Redevelopment Proposal of 2 - 16 Clifton Down Road by THAT Group

Daylighting Appraisal for the Clifton & Hotwells Improvement Society  
and  
Mall Garden's Residents Association

12 March 2019

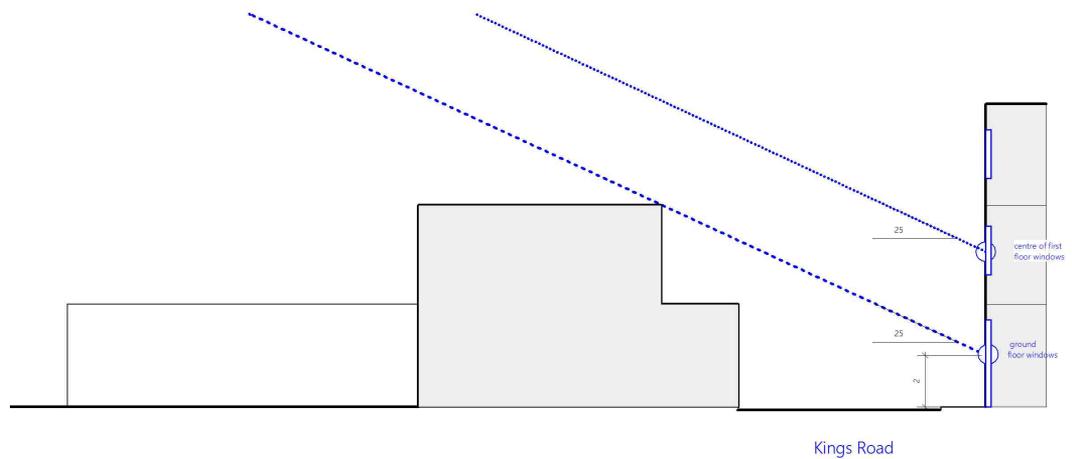
For the basement of Mortimer House, the report tabulates VSC daylight measurements of 19.6, 17.3, and 21. 1 in the basement and 24.0 and 24.1 on the ground floor.

Significant VSC daylight losses of up to 6.5% are reported for no less than 11 windows having a sub standard VSC of less than 27%. The BRE Guidelines state that '*for a room with non-continuous obstructions there is the potential for good daylighting provided that the vertical sky component... is not less than the value for a continuous obstruction of altitude 25degrees. This is equal to a vertical sky component of 27%.*' The minimum level of VSC for good daylighting therefore is 27%.

#### Daylighting Diagram for Kings Road as Existing

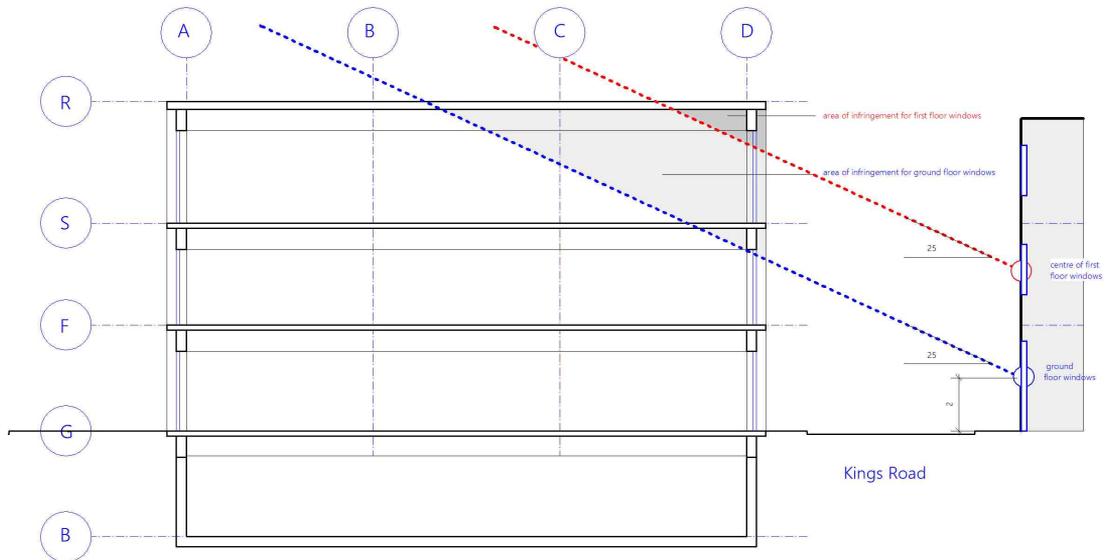
The diagram makes it clear that the setback of the existing building preserves good daylighting to both the shop windows on Kings Road as well as the assumed residential accommodation above. Had the two storey building been built right up to the back of pavement the achievement of 27% VSC daylighting could not have been assured.

## Daylighting Diagram for Kings Road as Proposed

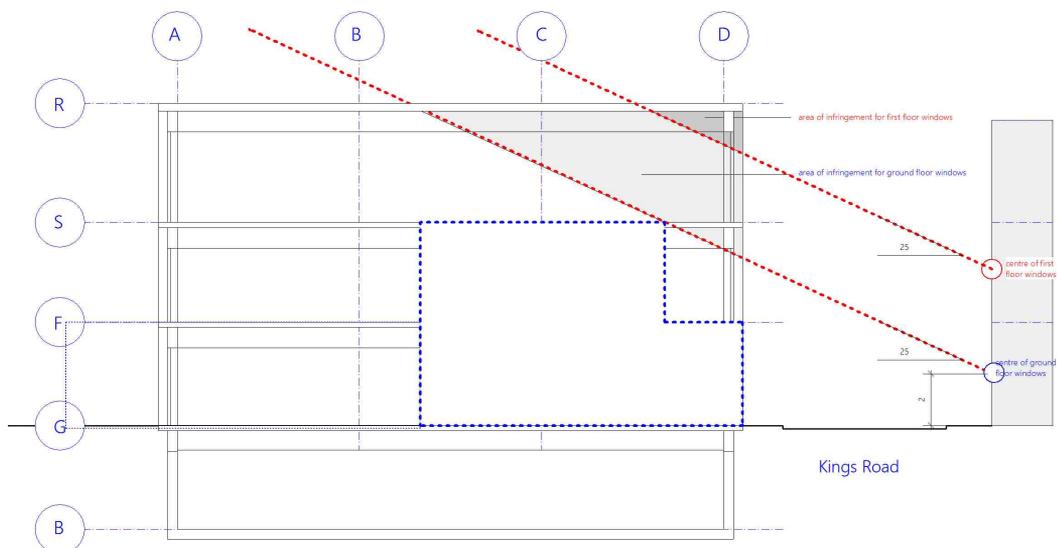
The diagram makes it clear that the proposed building fails to comply with the 25 degree test and that full VSC calculations are required. The evidence would suggest, as the proposed building presents a continuous skyline, is that good daylighting would **not** be preserved neither to the shop windows on Kings Road nor to the assumed residential accommodation above.
